Title: TRACE-PAD INTERFACE FOR IMPROVED SIGNAL
QUALITY

Atty's Docket No.: 51636/142

PRELIMINARY AMENDMENT

Fig 1A Prior Art

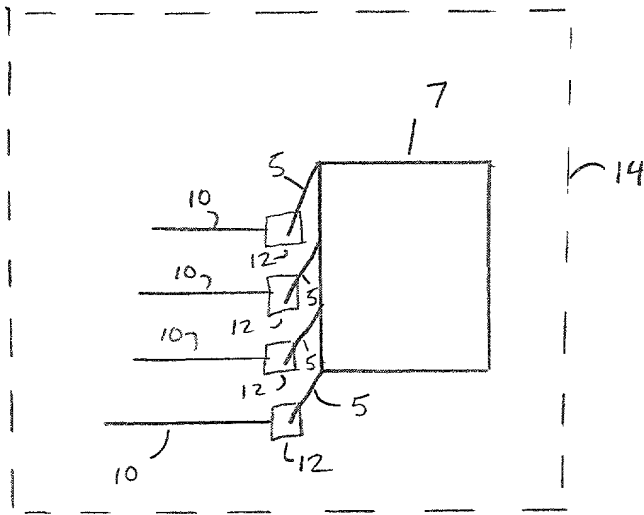
Figure 1A has been added. It shows a schematic diagram of the prior art. This is a diagram of a component 7 with multiple leads 5 on a printed circuit board 14. It shows a component 7 with multiple leads 5 connected to a pad 12 on the printed circuit board 14 as

described on page 1, lines 8-11. The pads are connected to traces 10 at 90° angles as is described on lines 13-19.

On page 1, line 10, after "components" add --, such as component 7 in Fig. 1A--.

--Fig. 1A is a schematic diagram of a component on a printed circuit board as is in the prior art; --

Fig 1B

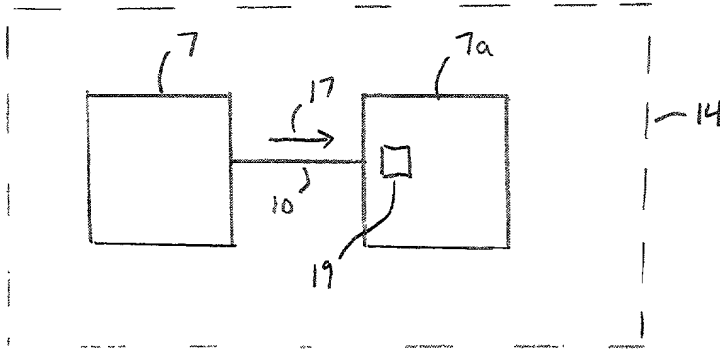
Figure 1B has been added. It shows a block diagram of two components, 7 and 7a, connected on a printed circuit board 14. The components are connected via a trace 10 as is described on page 1, lines 13-15. Digital signals 17 travel from component 7 to component 7a on printed circuit board 14 as is described on page 2, lines 2-4. The destination component 7a has an input receiver 19 which is triggered by the digital signal 17 as is described on page 2, line 4.

On page 2, line 3, replace "As" with --Referring to Fig. 1B, as--.

--Fig. 1B is a block diagram of two components connected on a printed circuit board; --

Fig 1C

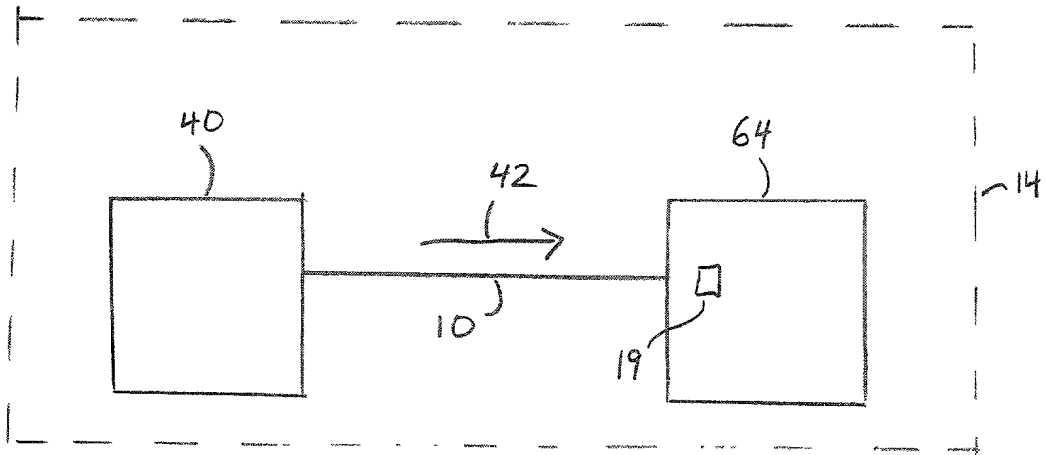
Figure 1C has been added. It shows a block diagram of a memory controller and memory as an example of two components connected on a printed circuit board. On page 2, lines 5-7, the memory controller and the memory are described as an example of the description on page 2, lines 1-5. Therefore, the diagram of Figure 1C is almost identical to that of Figure 1B, the diagram depicting the description of page 2, lines 1-5. Figure 1C has component 7 replaced by memory controller 40, digital signal 17 replaced by control signal 42, and component 7a replaced by memory 64. This is in accordance with the specific example described on page 2, lines 5-7.

On page 2, line 7, after "example" add --, as shown in Fig. 1C--.

--Fig. 1C is a block diagram of a memory controller and memory as an example of two components connected on a printed circuit board; --

Figure 7

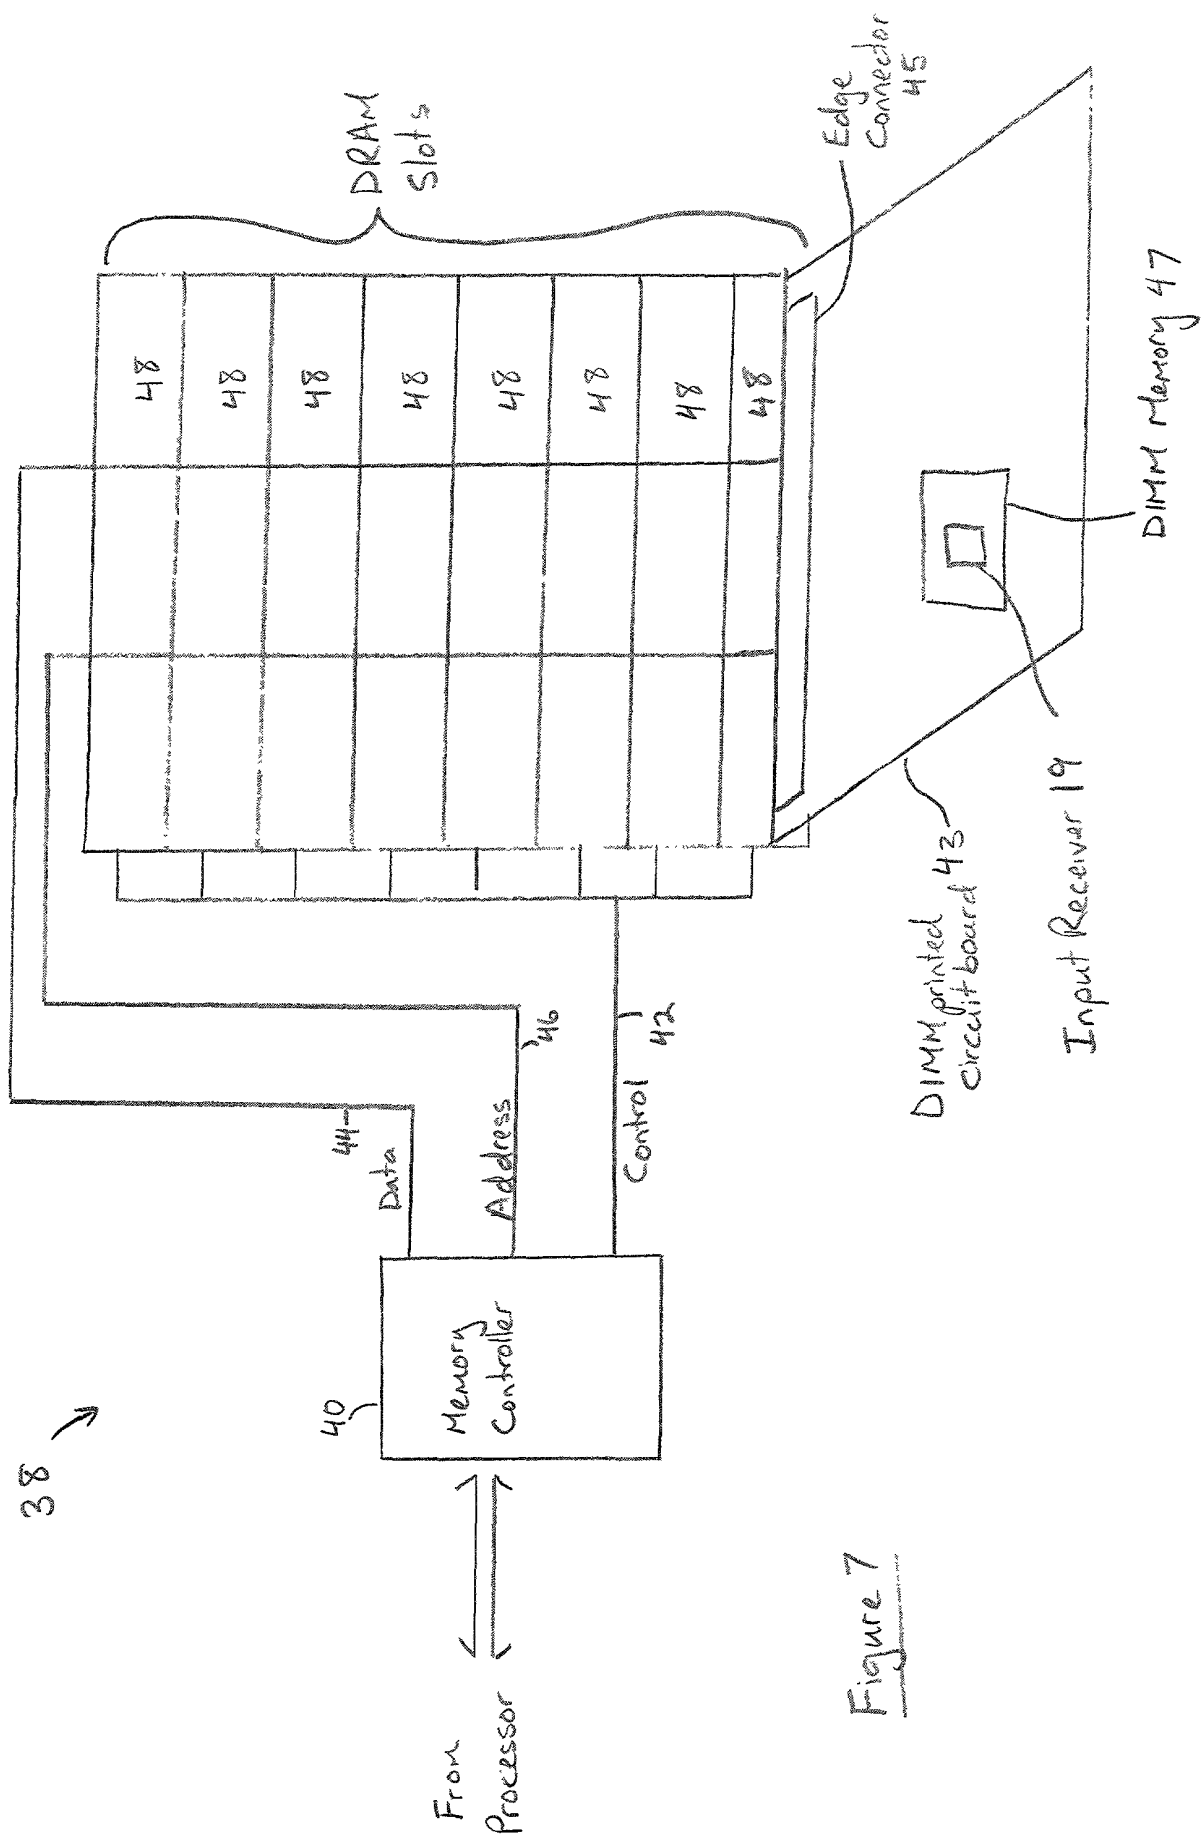
In Figure 7, a number of elements have been added. One such element is DIMM printed circuit board 43. The DIMM printed circuit board 43 is described on page 10, lines 14-15 as a separate printed circuit board where the DRAM DIMMs reside. DIMM printed circuit board 43 connects to slot 48 via an edge connector 45. The edge connector 45 was shown but previously unlabelled in Fig. 8. The edge connector is now labelled in Fig. 8 and is shown in Fig. 7. The

description on page 10, lines 13-14 shows how the DIMM is connected to DIMM slot 48. This has now been illustrated in Fig. 7 and described on page 10 after line 15. Another new element in Fig. 7 is DIMM memory 47 which resides on the DIMM printed circuit board 43. This is described on page 10, lines 14-15 and also lines 17-20 stating that the DIMM printed circuit board 43 is a separate printed circuit board than that containing the memory controller and that the DIMM memory 47 is contained on the DIMM printed circuit board 43. Combining Fig. 1C with the memory as described on page 10, lines 17-20 gives memory, in this case DIMM memory 47, with an input receiver 19, connected to memory controller 40 which sends control signals 42 to DIMM memory 47 via a trace. This has been illustrated in Fig. 7 in accordance with the description on pages 2 (as per Fig. 1C) and 10. As such, no new matter has been added with the amendment to Fig. 7.

On page 10, line 15, after "another circuit board" add --43. The DIMM printed circuit board 43 connects to slot 48 via an edge connector 45--.

FIG. 8

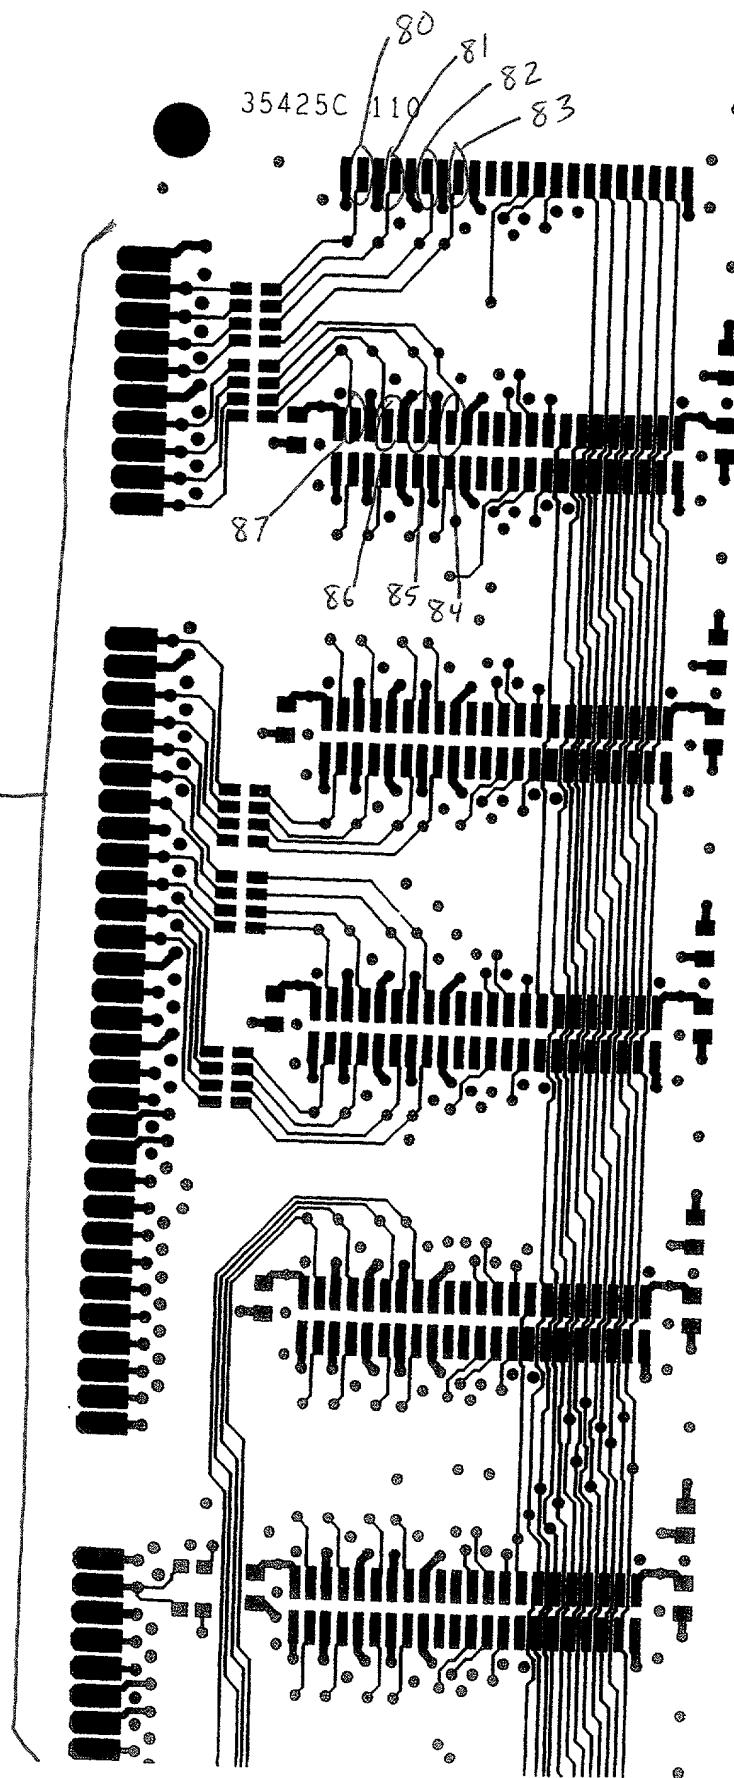
Fig. 8 has had reference numerals added to it. The drawing had been previously described on page 11, lines 4-6 as a DIMM printed circuit board made in the manner as described in the specification. As stated previously, the edge connector that was previously shown in Fig. 8 has now been identified by means of a reference numeral. The definition of a dual-in-line memory module (DIMM) was downloaded from *IT Windows Library*, produced by Penton Media Inc., <http://windowsitlibrary.com/Content/175/02/7.html> on December 12, 2000. A copy of this website is attached. It defines a DIMM as a "RAM package that holds several memory chips on a single circuit board and has a 168-pin single-row edge connector for insertion into the motherboard". An edge connector is an inherent part of a DIMM and was shown in the original Figure 8. The existence of a memory chip or component attached to the printed circuit board is also inherent in the structure of the DIMM. Areas 80-87 that can be seen to have the structure of the invention as is shown in Figure 4 have been marked. An explanation of this has been added

on page 11. As this is an explanation of the definition and inherent structure of the DIMM, this is not new matter.

--Referring to Fig. 8, the edge connector 45 attaches the DIMM printed circuit board to the printed circuit board containing the memory controller. The DIMM memory components attach to the DIMM printed circuit board. As can be seen from Fig. 8, areas 80-87 have the connect structure of the pads with the traces as described in the invention and as shown in Fig.
